REGIONAL REVIEW FINDING

ARC REVIEW CODE: R1801251

Name of Proposal: 1019 and 1033 Franklin Gateway

1019 AND 1033 FRANKLIN GATEWAY NOTIFICATION ONLY REVIEW
City of Marietta
Natural Resources Group Review Comments
January 26, 2018

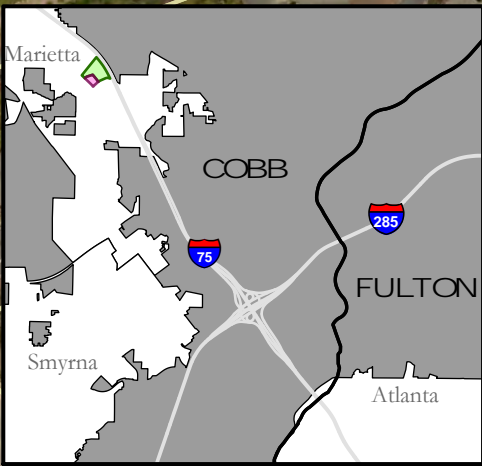
Other than Rottenwood Creek, which is identified as a blue-line, perennial stream, no other blue line streams are shown on or near the project property on the USGS coverage for the project area. Neither Rottenwood Creek nor any other state waters are shown on the submitted conceptual site plan. The property is subject to the requirements of the City of Marietta's stream buffer ordinance, which requires a 50-foot undisturbed buffer and additional 25-foot impervious setback on applicable streams. The buffers should be shown on the plans and any intrusion into the buffers may require a variance from the City. Likewise, Rottenwood Creek, as well as any other waters of the state that may exist on the property will be subject to the State 25-foot Sedimentation and Erosion Control buffer. The buffer should also be shown as determined in accordance with state law and DNR guidance as applied to this property. Any intrusions into the state buffer will also require a variance.

The project should adequately address the impacts of the proposed development on stormwater runoff and downstream water quality. During construction, the project should conform to the relevant state and federal erosion and sedimentation control requirements. After construction, as with all development, water quality will be impacted due to polluted stormwater runoff. The amount of pollutants that will be produced after construction of the proposed development are dependent on the type and intensity of the use and the impervious coverage, which will affect the design of stormwater controls for the project.
